Onondaga County Planning Board

MEETING MINUTES

October 07, 2026

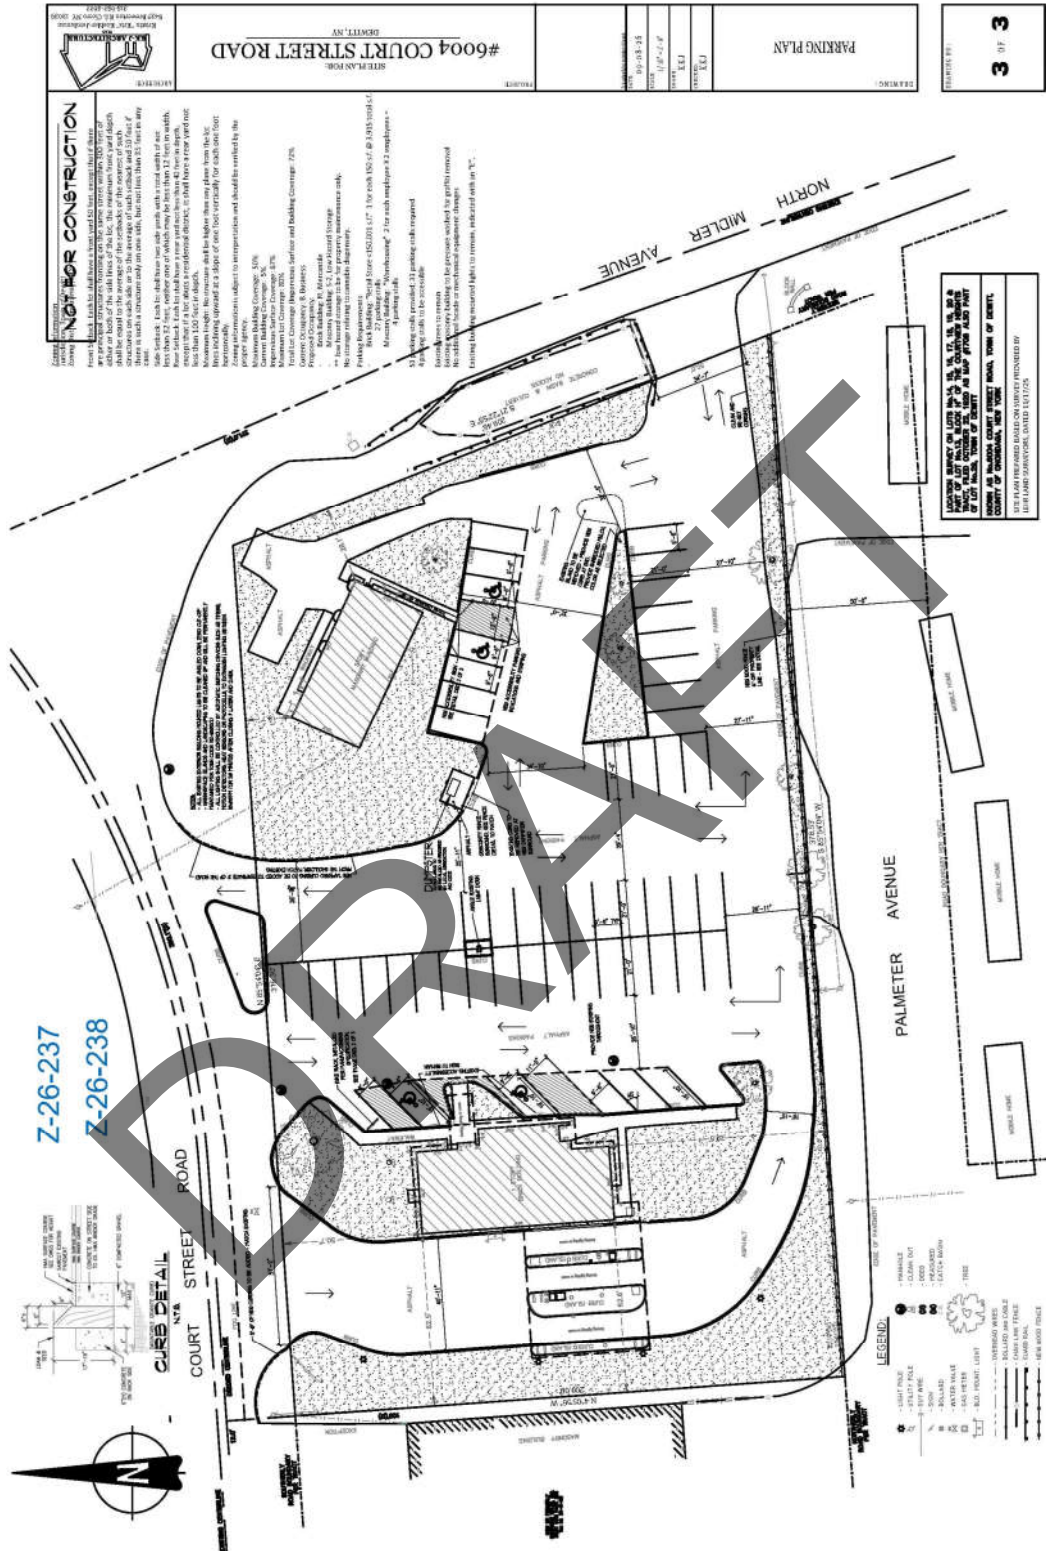
1. The Town is encouraged to consider consolidation of the multiple driveways on Court Street Road to improve mobility and provide opportunities to add more landscaping along the road frontage.
2. Every municipal review provides the opportunity to improve site appearance and the applicant and the municipality are encouraged to improve site design and improve conditions by expanding landscaped areas along the road frontages and around the parking lots.

Access:	Court Street Road, North Midler Avenue, and Palmetter Avenue are all local roads in this area. No changes to the existing access are proposed. Per the Parking Plan, the site has multiple access points to Court Street Road, including an ingress-only entrance along the western side of the frontage providing access to the drive-thru, a full-access driveway to the parking lot, and then an egress-only exit near the eastern side of the parking lot. A full-access driveway to North Midler Avenue is located in the southeast corner of the site. The site also has frontage on, but no access to Palmetter Avenue. A narrow strip of minimal vegetation separates the lot and street. A fence is proposed along the length of the Palmetter Avenue frontage.
Stormwater:	Per the Environmental Assessment Form (EAF) dated 2/25/26, zero acres of the 1.63-acre site will be disturbed by the proposed project. The site is located in an Onondaga County Drainage District for Bear Trap and Ley Creek, which is maintained by the Department of Water Environment Protection in this area. ADVISORY NOTE: Per the NYS Department of Conservation (NYSDEC), any project that cumulatively disturbs one acre or more of land must be covered under the NYS SPDES Permit. The municipality is advised to ensure that the applicant has obtained the appropriate permits from the NYS Department of Environmental Conservation prior to municipal approval.

Wetlands: GIS mapping shows a federally regulated Class C stream, a tributary of the South Branch of Ley Creek, runs along the eastern boundary of the site, along North Midler Avenue in a constructed channel. The driveway to North Midler Avenue crosses the channel. The concrete basin and culvert containing this stream is shown on the plans and no changes to this area are proposed.

NOW THEREFORE BE IT RESOLVED, that the Onondaga County Planning Board recommends the following MODIFICATION(S) to the proposed action prior to, or as a condition of, local board approval of the proposed action:

The Onondaga County Department of Water Environment Protection requires projects within an Onondaga County Drainage District that require a Stormwater Pollution Prevention Plan (SWPPP) to submit a copy to the Department for review. The municipality must ensure any mitigation as may be determined by the Department is reflected on project plans prior to, or as a condition of, municipal approval.

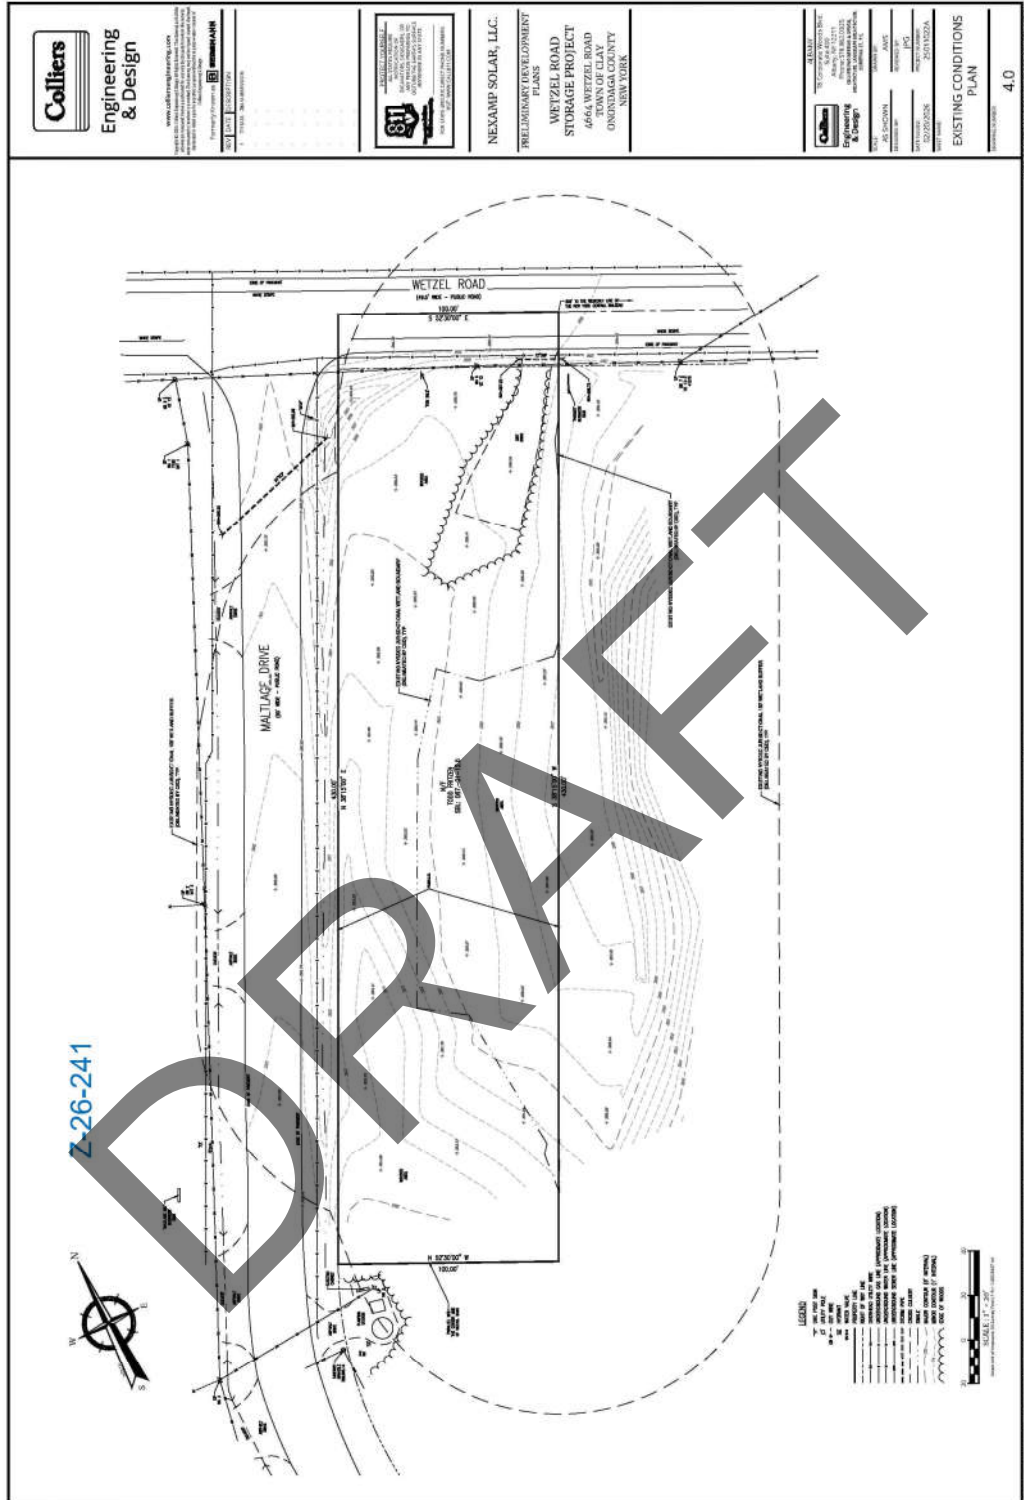
Access:	Two driveways to Maltlage Drive, a local road, are to provide access to the site. A 15'-

wide driveway to the BESS and a 20'-wide driveway will provide access to the utility connection equipment at the rear of the site.

Prior plans showed a proposed driveway onto Wetzel Road, which has been removed.

Wetland regulations require the applicant to contact the NYS Department of Environmental Conservation to confirm the presence of state wetlands and/or the 100-foot state wetland buffer on the site. All delineated and confirmed wetlands and date of delineation should be shown on the plans for the site and any necessary permits should be obtained for any proposed development or placement of fill in a wetland, or drainage of any confirmed wetlands and buffers, prior to or as a condition of plan approval.

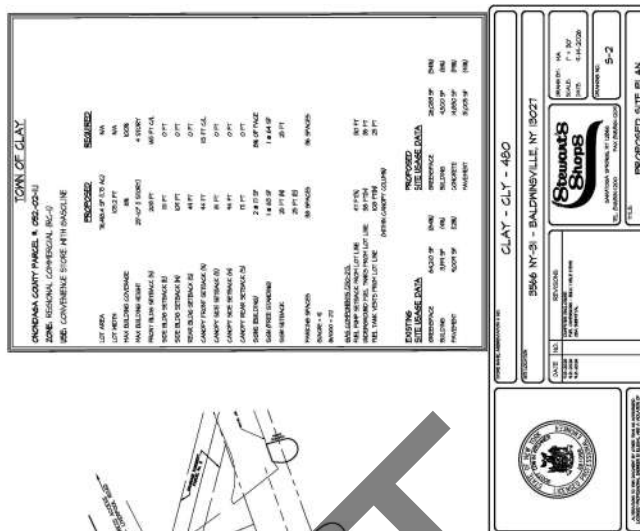
Access:	Per the Site Plan, the site will have full access driveways to both the Kimbrook Plaza driveway to the east and the plaza's internal road to the rear (south). The applicant also proposes a right-in/right-out driveway to NYS Route 31. ADVISORY NOTE: The proposed driveway onto NYS Route 31 requires highway access and work permits from the NYS Department of Transportation and will be subject to the availability of sight distance.
Bike/Ped/Transit:	No sidewalks or pedestrian infrastructure are shown on the plan along road frontages in front of the site or connecting the building to the plaza's internal roadways. NYS Route 31 does have sidewalks east of site. Per the Central New York Regional Transportation Authority (CENTRO), Oswego Road has public transit service and bus stops are located at the intersection of Oswego Road and NYS Route 31, approximately 700' from the site.
Easements:	Per the Topographic Survey dated 7/31/26, the site has multiple easements on or near the subject parcel: ·An Ingress & Egress Easement occurs in the location of the Kimbrook Plaza driveway and the eastern boundary of the site occurs within this easement. ·A 30'-wide OCWA easement is located adjacent to the Kimbrook Plaza driveway. ·The Ingress & Egress and OCWA easements also occur in the location of the plaza's internal road, are noted as "Relocated", possibly relocated from the abandoned internal driveway, and appear to occur adjacent to the southern site boundary. ·A sanitary sewer easement extends from the southern site boundary into the plaza area. Per the Proposed Site Plan dated 9/21/26, it appears the proposed work will be

Stormwater:	Per the Environmental Assessment Form (EAF) dated 9/21/26, 1.25 acres of the site will be disturbed by the proposed project and the project will result in 1.15 acres of impervious surface. Per the EAF, "on site stormwater handling with overflow to established conveyance systems." Swales, basins, or other stormwater structures are not indicated on the plans. ADVISORY NOTE: Per the NYS Department of Conservation (NYSDEC), any project that cumulatively disturbs one acre or more of land must be covered under the NYS SPDES Permit. The municipality is advised to ensure that the applicant has obtained the appropriate permits from the NYS Department of Environmental Conservation prior to municipal approval.
Drinking Water:	A new connection to public drinking water is proposed for the new building. Per the EAF, the proposed development is anticipated to utilize 1,100 gallons of drinking water per day. ADVISORY NOTE: OCWA requires the applicant to contact its Engineering Department to determine water availability and service options, and obtain hydrant flow testing information and backflow prevention requirements.

1. The New York State Department of Transportation requires the applicant to submit plans and coordinate NYS Route 31 access with the Department. The municipality must ensure any mitigation as may be determined by the Department is reflected on the project plans prior to, or as a condition of, municipal approval.

3. The Onondaga County Department of Water Environment Protection requires the municipality to ensure that no construction of permanent structures occurs which may encroach into the county sanitary sewer easement or affect the county infrastructure. The applicant must contact the Onondaga County Department of Water Environment Protection (WEP) Flow Control Division for any infrastructure-related disturbance of land within the county easement prior to, or as a condition of, municipal approval. County-owned infrastructure must be shown on the plans prior to, or as a

6. The applicant is encouraged to incorporate more plantings and landscaping to both improve the aesthetics of the site and improve stormwater conditions.

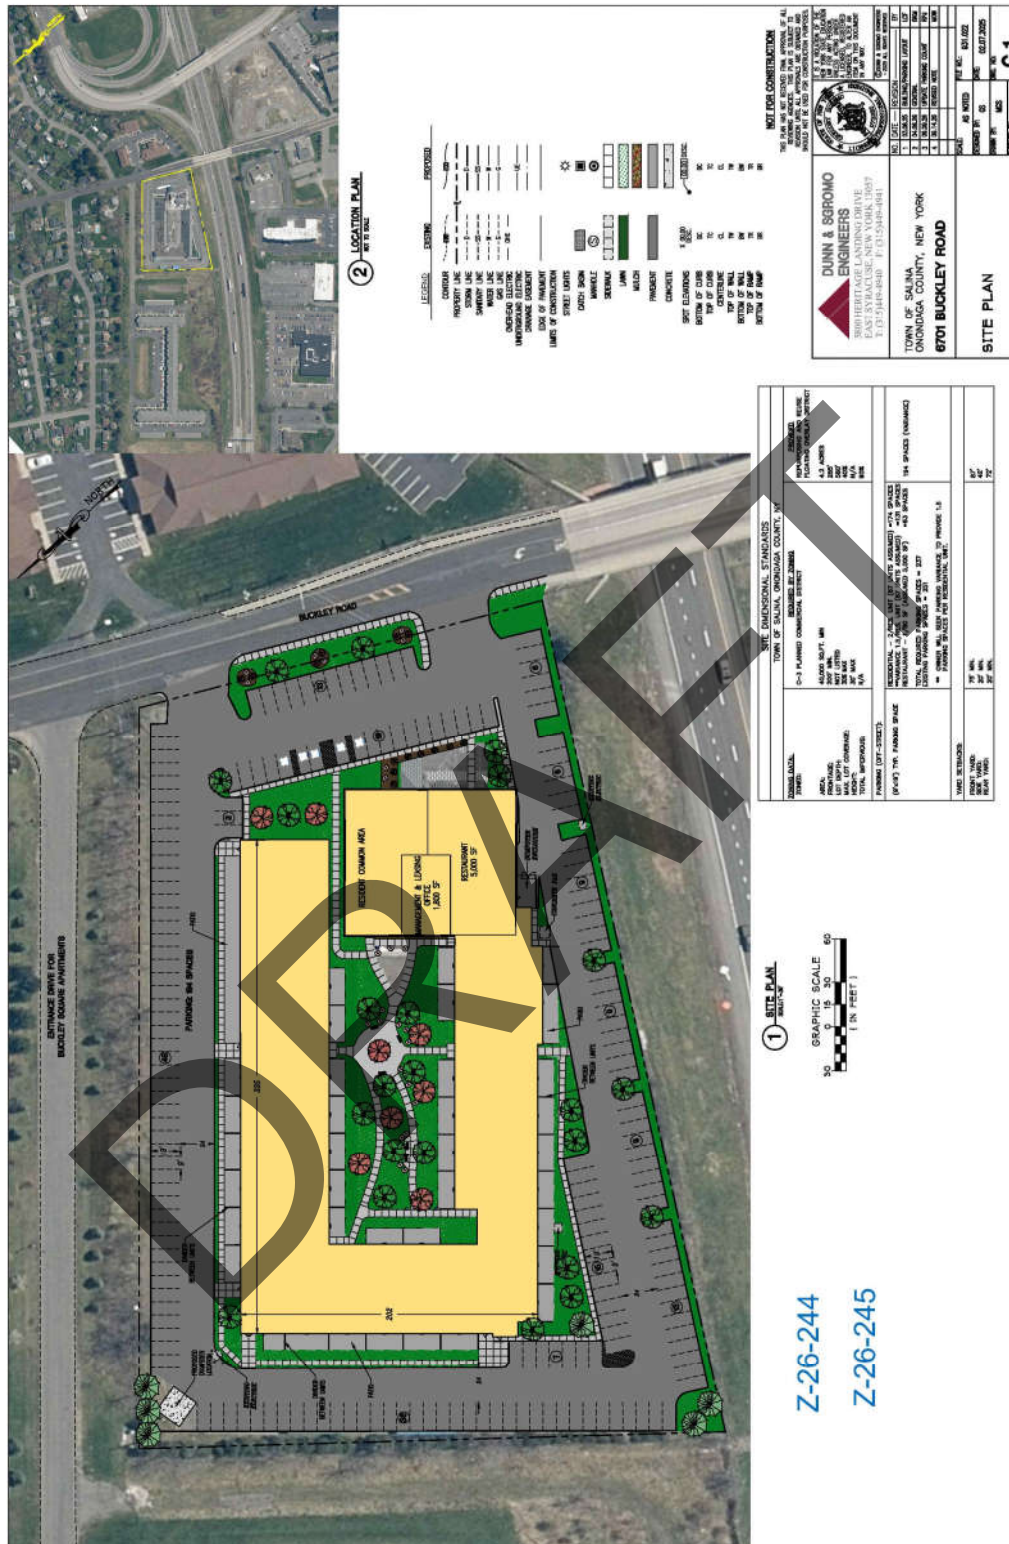
Parking:	Per a chart on the Site Plan, the site has 251 existing spaces, 237 are required by Town Code, and the proposed redevelopment will result in 194 parking spaces.
Variances:	The applicant requests two variances: to allow 40% lot coverage where 30% is allowed and to allow 1.5 parking spaces per dwelling unit (DU) where 2 spaces per DU are required.
Stormwater:	Per the Environmental Assessment Form (EAF) dated 9/8/26, 0.98 acres of the site will be disturbed by the proposed project. It appears impermeable surface on site will be reduced. Stormwater infrastructure is not indicated on the plans. The site is located in an Onondaga County Drainage District for Bear Trap and Ley Creek, which is maintained by the Department of Water Environment Protection in this area. ADVISORY NOTE: Per the NYS Department of Conservation (NYSDEC), any project that cumulatively disturbs one acre or more of land must be covered under the NYS SPDES Permit. The municipality is advised to ensure that the applicant has obtained the appropriate permits from the NYS Department of Environmental Conservation prior to municipal approval.

1. The Onondaga County Department of Transportation requires the applicant to submit plans and coordinate Buckley Road access with the Department. The municipality must ensure any mitigation as may be determined by the Department is reflected on the project plans prior to, or as a condition of, municipal approval.

2. The site is located within an Onondaga County Drainage District. If a Stormwater Pollution Prevention Plan (SWPPP) or drainage report are required, a copy of the report must be submitted to the Onondaga County Department of Water Environment Protection for review. The municipality must ensure any mitigation as may be determined by the Department is reflected on project plans prior to, or as a condition of, municipal approval.

3. The New York State Thruway Authority (NYSTA) requires a drainage and grading plan and a lighting plan to the Authority for review. The municipality must ensure any mitigation as may be determined by the NYSTA is reflected on the project plans prior to, or as a condition of, municipal approval. No increase to the amount of site drainage entering onto the Thruway as a result of this construction will be permitted.

The Board encourages the Town and applicant to modify the site plan and coordinate with the adjacent landowner along Buckley Square Drive to improve and enhance landscape screening for adjacent residential uses.
